PUBLIC MEETING NOTICE AND AGENDA
PLANNING AND ZONING COMMISSION MEETING

SUBJECT: Conditional Uses and Development Plan for a Starbucks café with a drive-through and outdoor patio at 4501 W. Algonquin Road

- Development Plan
- Owner:* Lakepointe-LITH Development, LLC / Plote Properties
- Applicant:* Algonquin LIH, LLC / Evolve Commercial Real Estate, LLC
- Purpose:* To allow the construction of a Starbucks café with a drive-through and outdoor patio

SHEET TITLE:
SCHEMATIC EXTERIOR ELEVATIONS

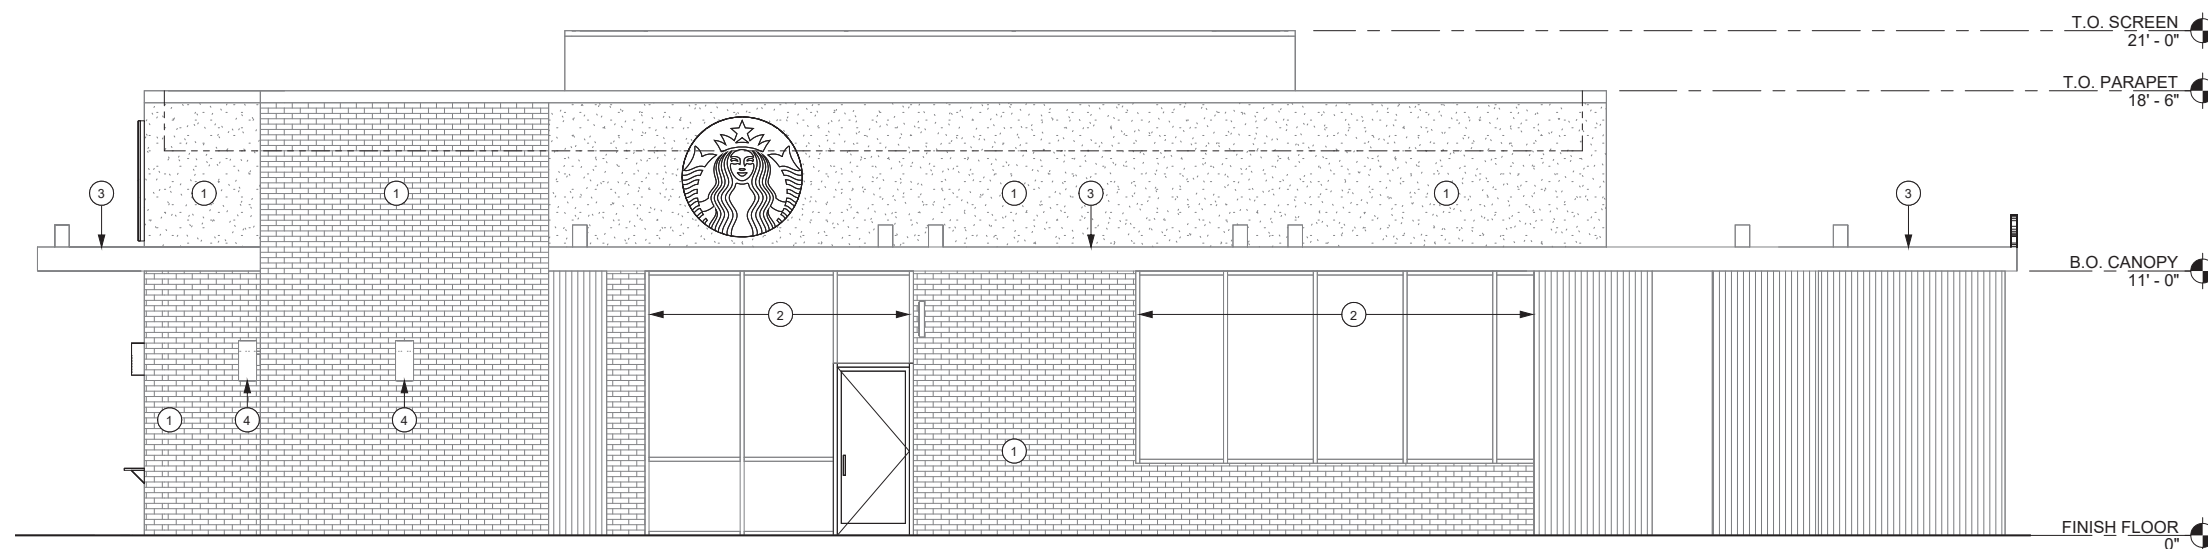
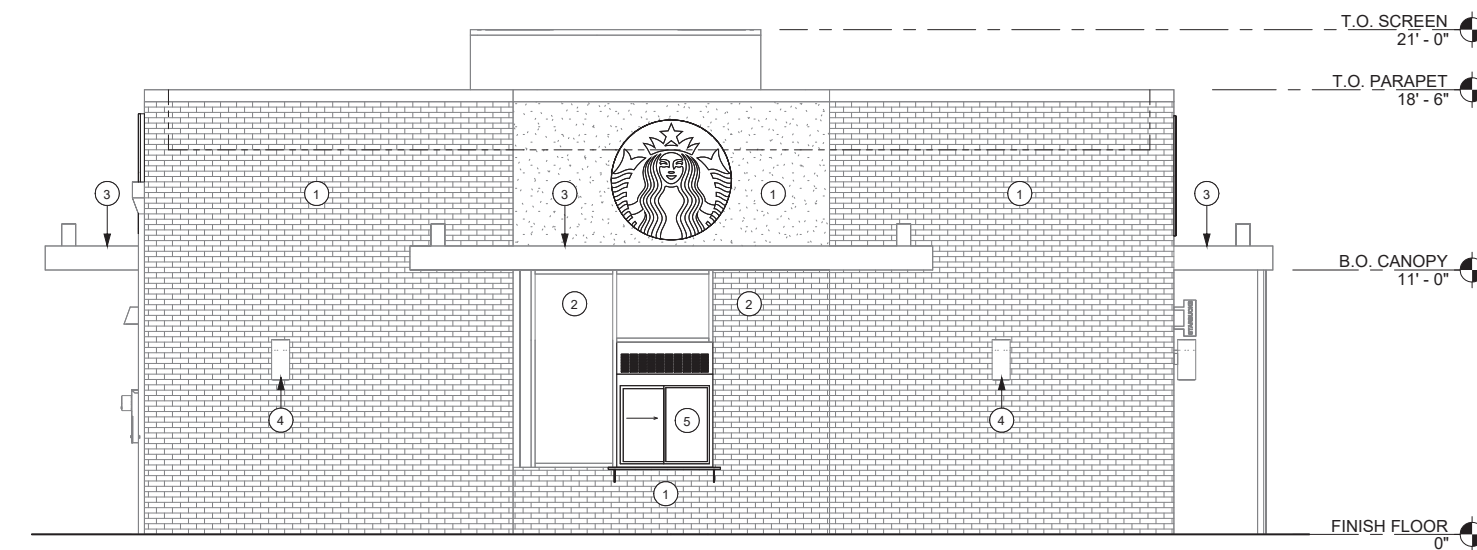
The exterior of the proposed building is designed in a modern style with a combination of materials, including gray brick, gray EIFS (Exterior Insulation Finishing System) and dark brown composite wood panels. As requested by Village staff, the applicant has revised the drawings to comply with Section 24.16.P of the Municipal Code, which requires the new building to include decorative exterior elevations consisting of a minimum of 75 percent brick, stone, or other masonry material per each elevation. The most recently revised black-and-white exterior elevation drawings show brick on a majority of the building, with EIFS on only the upper areas and with wood composite materials adjacent to the outdoor patio areas. Staff finds that the exterior building design complies with the code requirement. It should be noted that the exterior building elevations shown on the color signage drawings are an old version that only shows brick on the corners of the building, but the applicant has committed to providing the exterior materials shown on the black-and-white exterior elevation drawings. However, none of the colors and materials are specifically labeled on the black-and-white drawings. Therefore, to ensure code compliance, if the Planning and Zoning Commission recommends approval of the development plan, staff suggests that the recommendation include the condition that the building shall include exterior elevations consisting of a minimum of 75 percent gray brick to comply with the standards in Section 24.16.P of the Municipal Code.

2 ELEVATION @ WOODEN SCREEN
Scale: 1/2" = 1'-0"

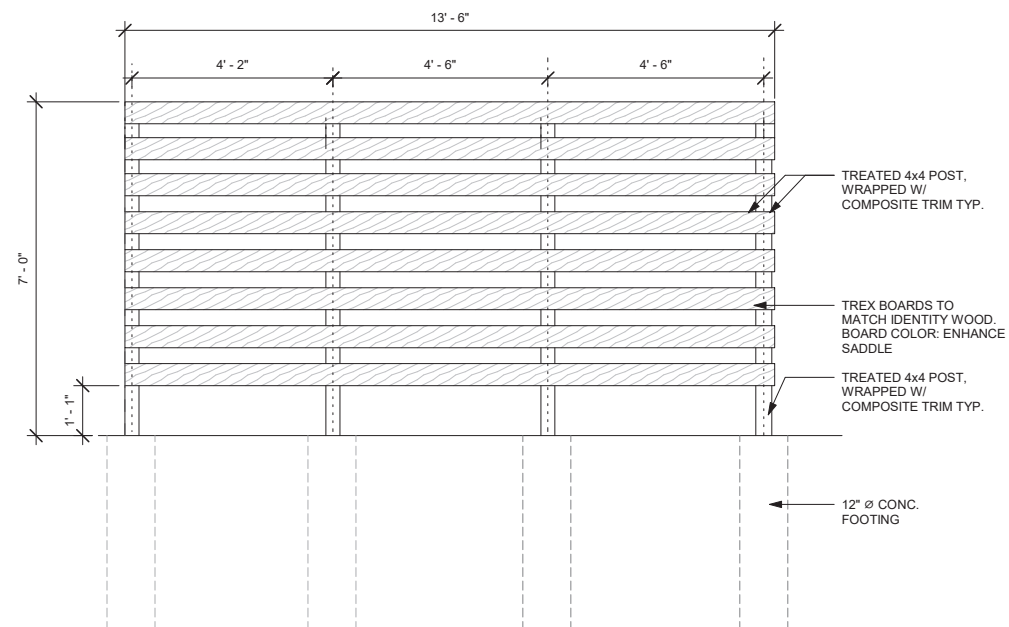
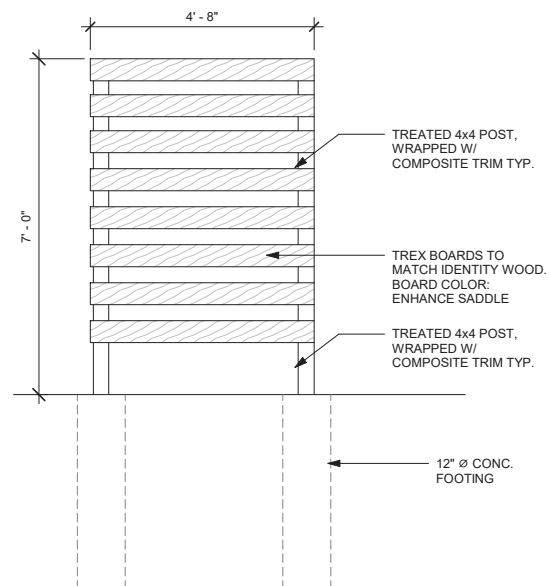
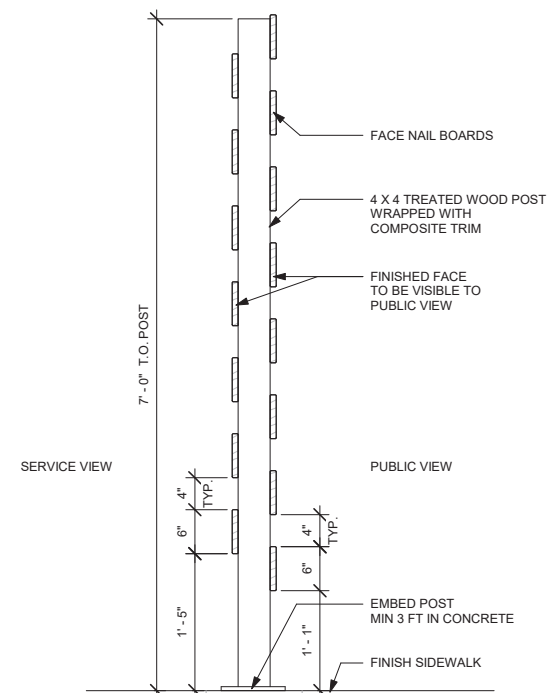
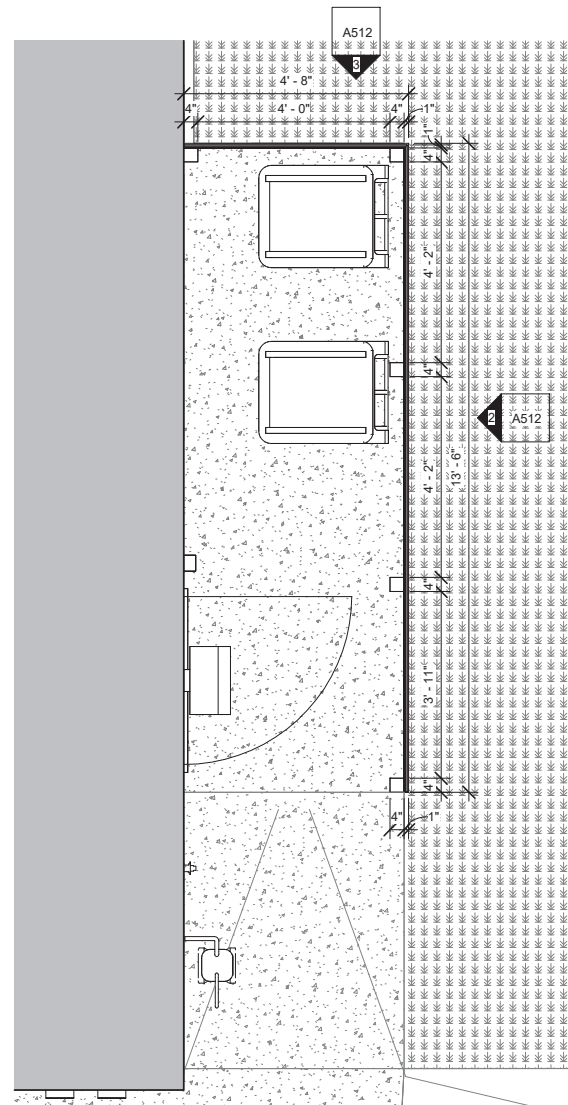
It should be noted that the color signage drawings show a screening wall on the south side of the building that includes the label "Placeholder Artwork by Starbucks." Signs mounted on fences and walls are expressly prohibited by Section 16.3.G of the Zoning Code, so no Starbucks logos or products would be allowed to be shown on the wall as "artwork." Further, artwork may not be hand painted on exterior walls per Section 16.3.P of the Zoning Code. The applicant has indicated that this is an old detail on the signage drawings, and the applicant has committed to instead provide the wooden screening fencing shown on the third page of the black-and-white exterior elevation drawings.

PHOTOMETRICS PLAN

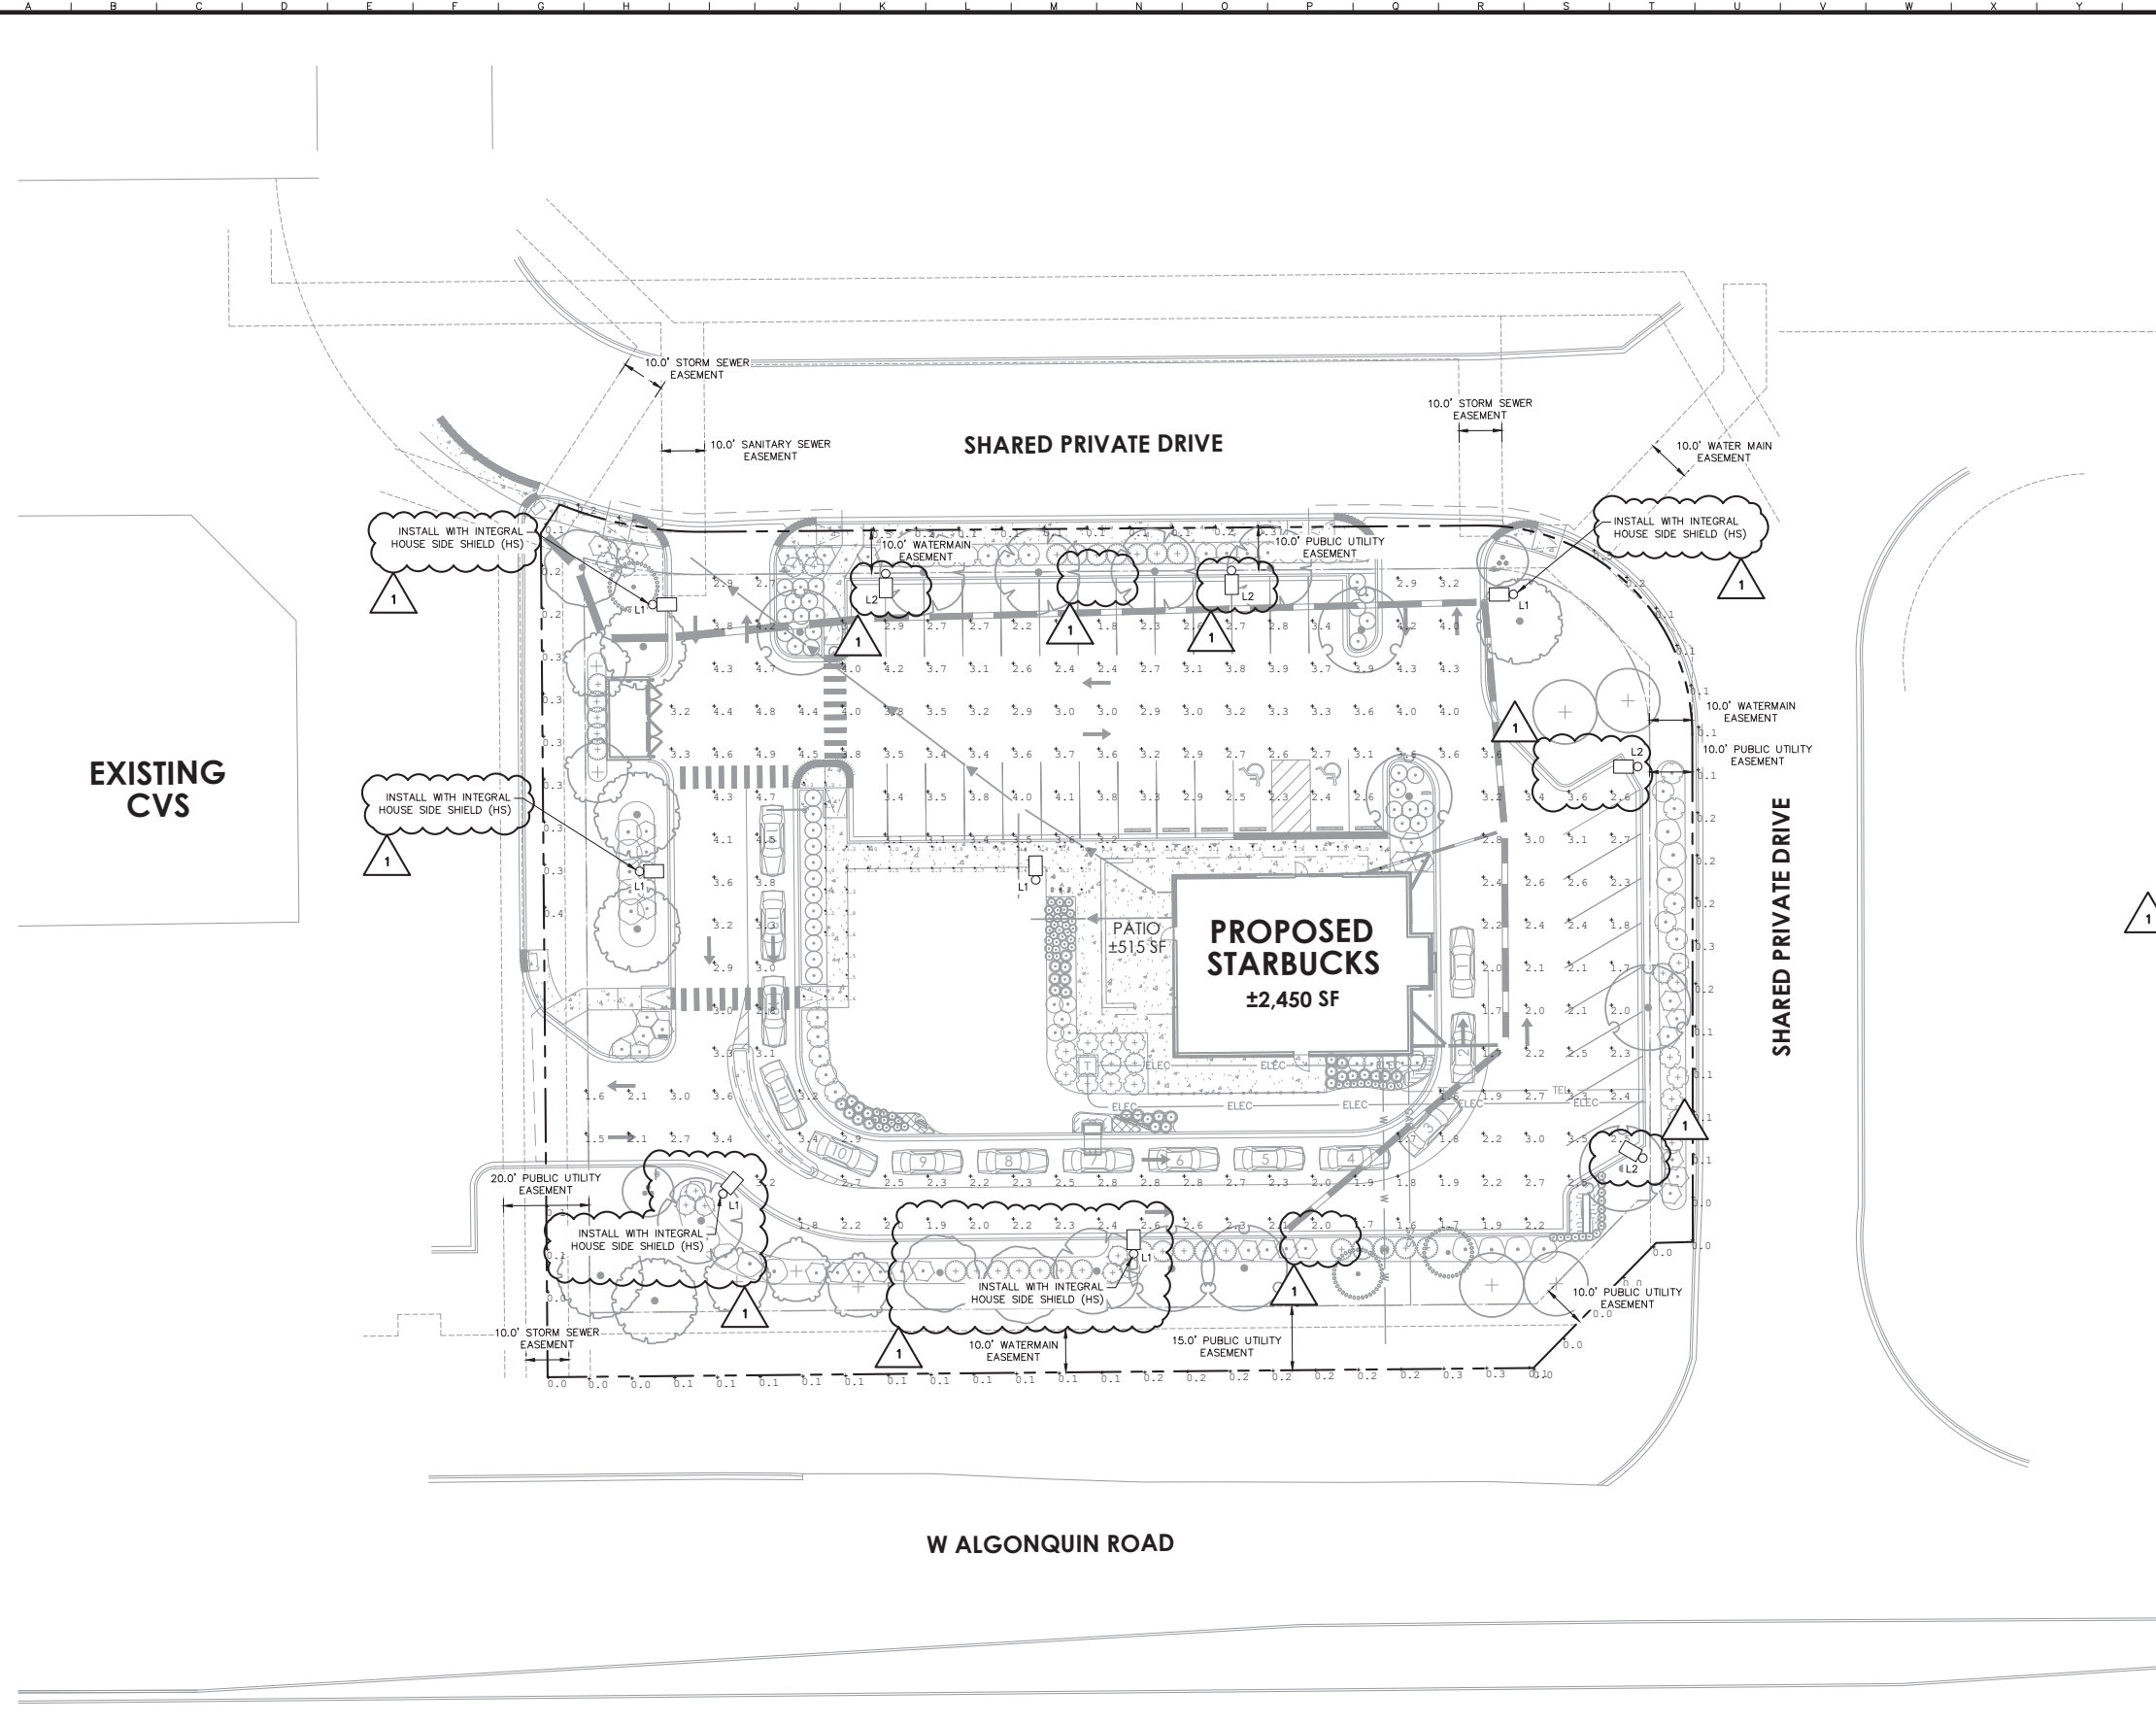
The applicant has submitted lighting plans to show the type of light fixtures and the lighting levels. Site lighting is provided by ten LED light fixtures mounted on poles. The fixtures will be mounted at a height of 22 feet, which complies with the height limit of 25 feet in Section 18.4-3.G.2.a.i of the Zoning Code. The plans show that the parking lot and adjacent sidewalk areas will be sufficiently illuminated, and that the lighting will not create a nuisance by spilling over onto adjacent properties. The highest lighting level at the edge of the subject property will be 0.5 footcandles, which complies with the limit in Section 18.4-3.G.3.b of the Zoning Code.
